SECTION 4: ERRATA

The following are revisions to the Draft Subsequent EIR. These revisions are minor modifications and clarifications to this document and do not change the significance of any of the environmental issue conclusions within the Draft Subsequent EIR. The revisions are listed by page number. All additions to the text are underlined (underlined) and all deletions from the text are stricken (~~stricken~~).

CITY OF SAN RAMON • SAN RAMON CITY CENTER PROJECT
DRAFT SUBSEQUENT ENVIRONMENTAL IMPACT REPORT

Exhibit 4.8-1 General Plan Designations

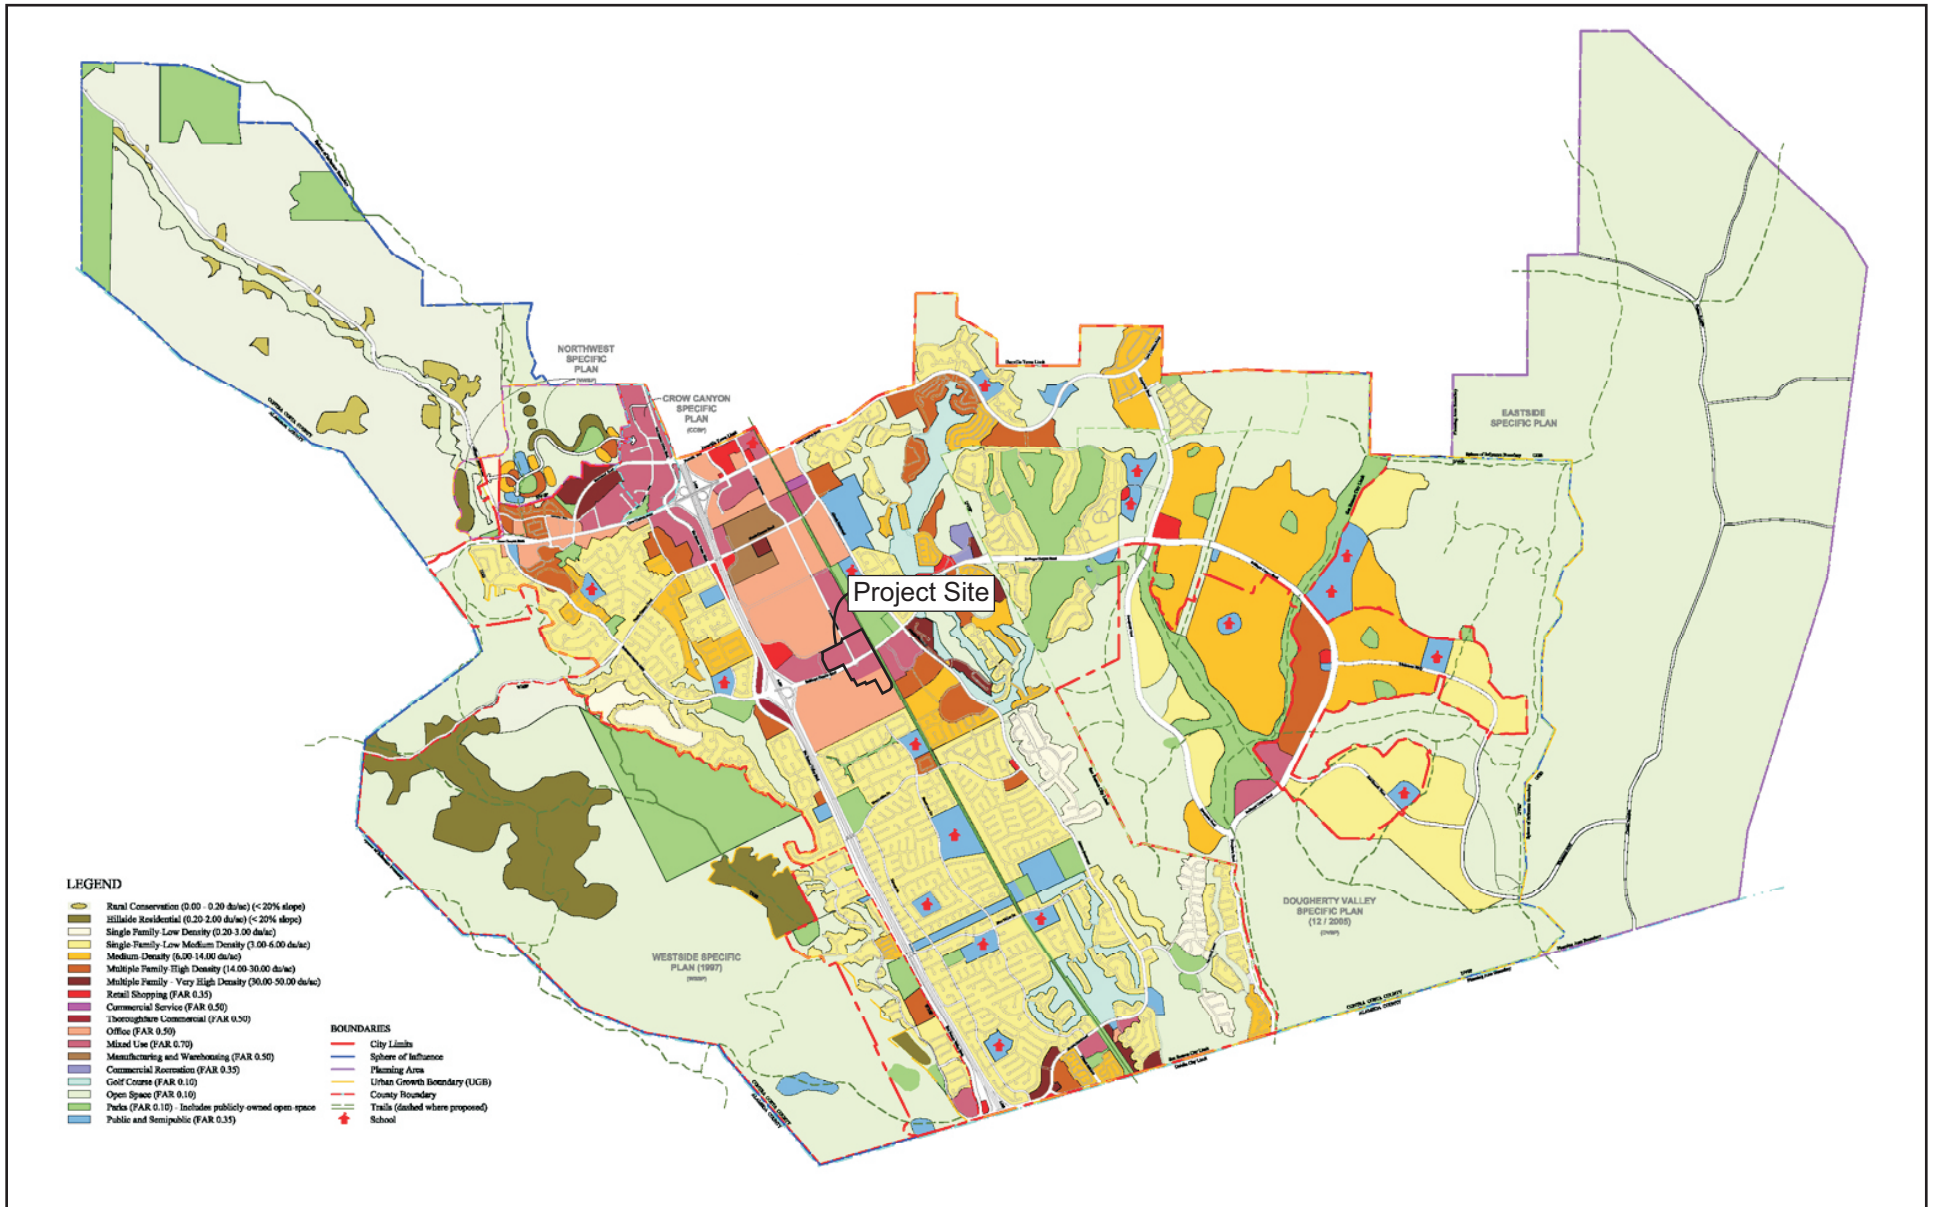
This exhibit has been modified to show the correct location of the project site.

Exhibit 4.8-2 Zoning Ordinance Designations

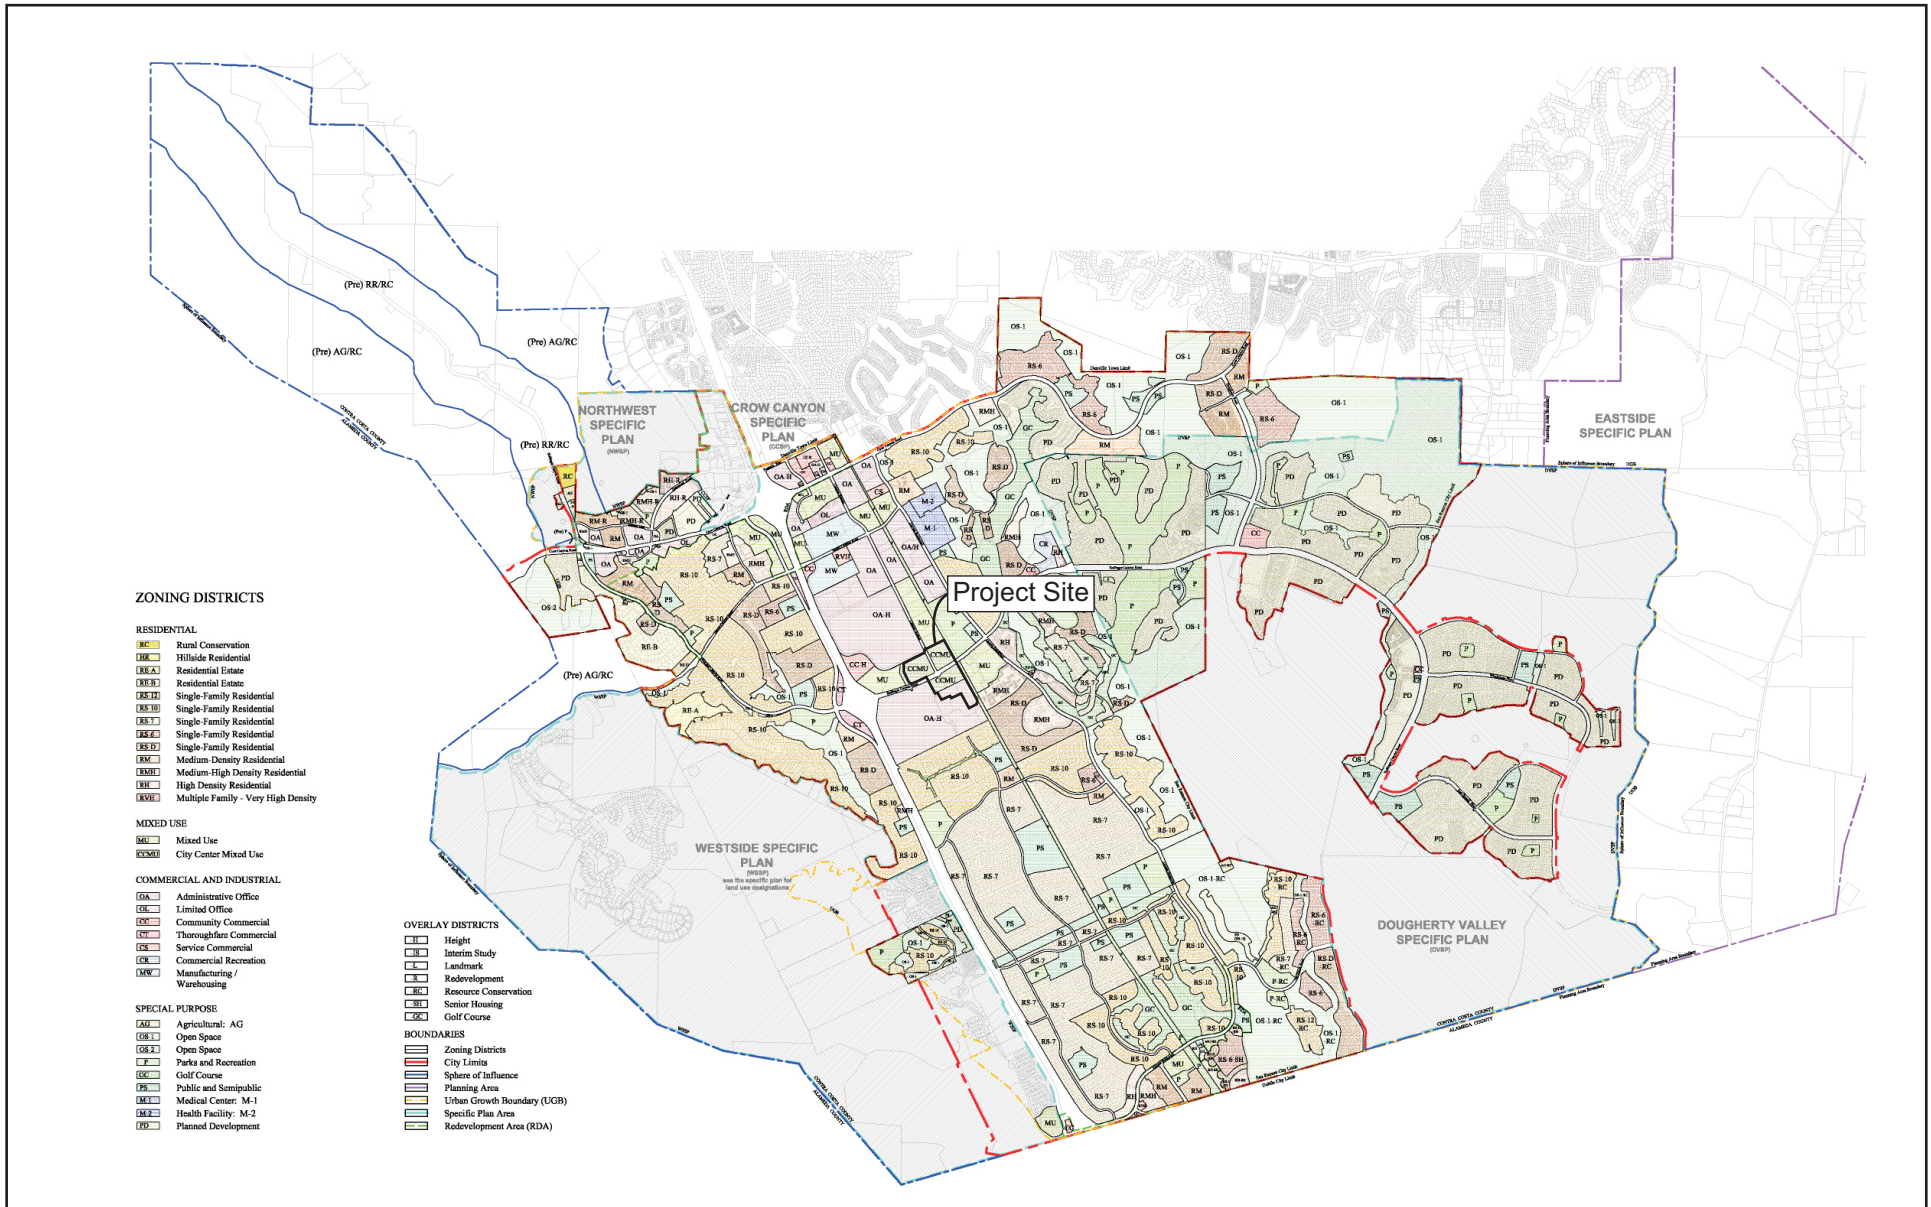
This exhibit has been modified to show the correct zoning designation for Parcel 1B and the correct location of the project site.
